EVERSTEAD
SHOP DRAWINGS/SUBMITTAL REVIEW

JOB No.	27/55622
DESCRIPTION	Summit Homes - Osage #9 - Juneau Townhome
JOB ADDRESS	3720 SW Wash. Dr.
CITY	Lee's Summit, MO
DESIGNER	Scott Clevenger
DATE	3/20/2023

ROOF
TRUSS LAYOUT
PAGE
1 of 1

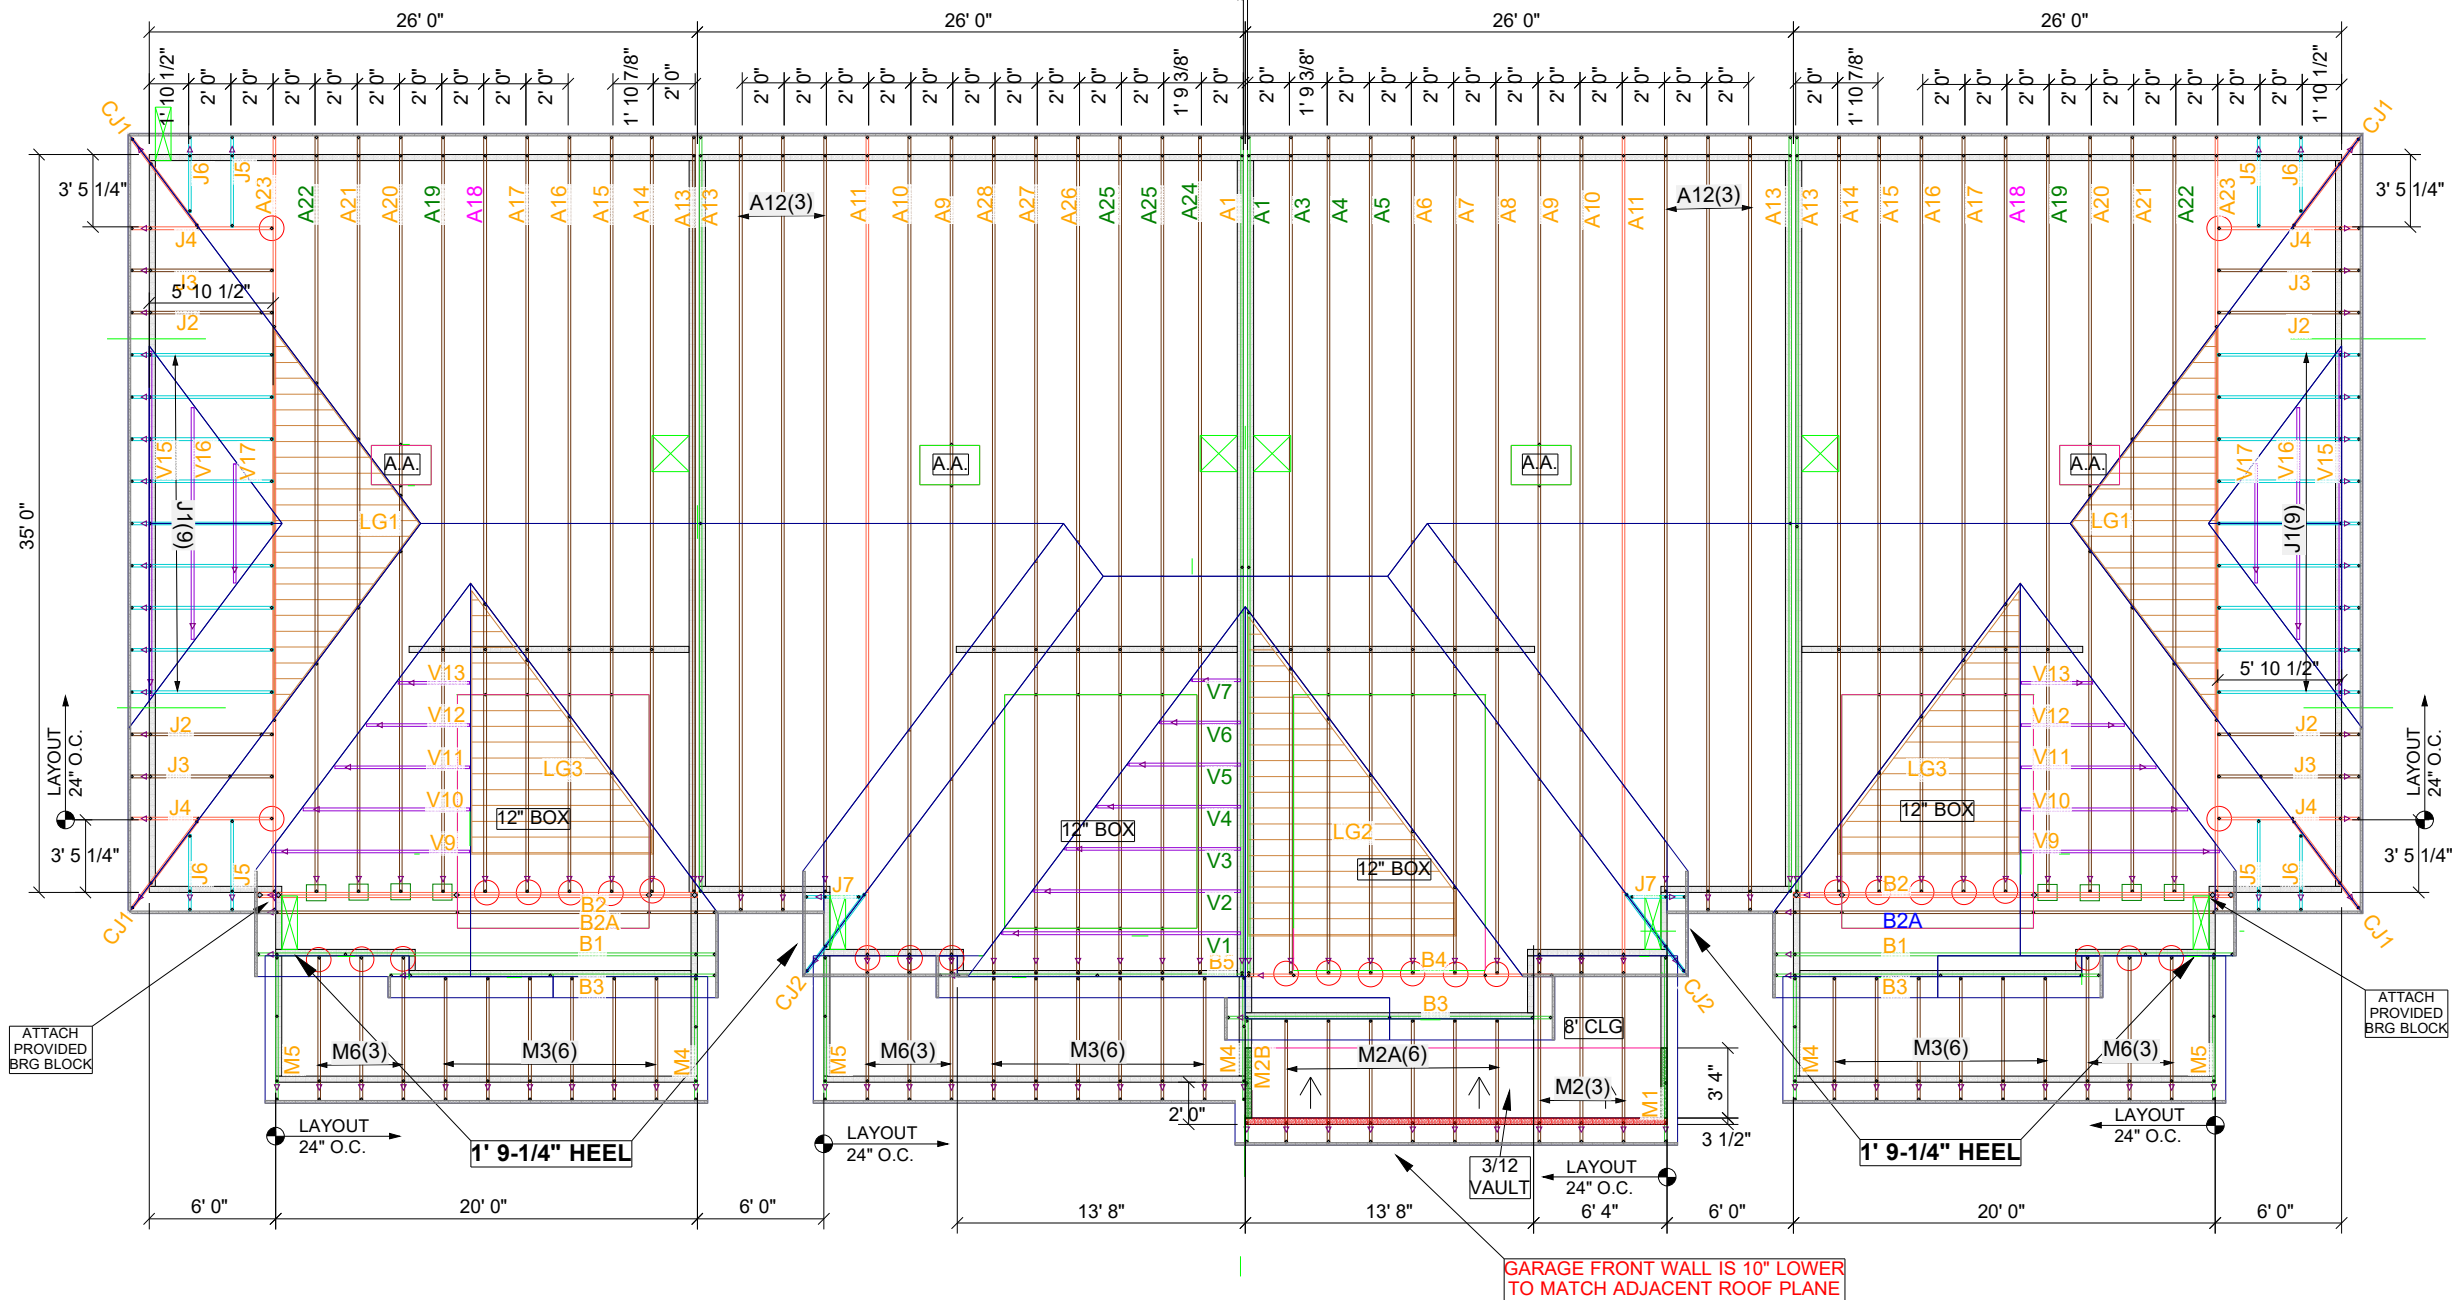
APPROVED
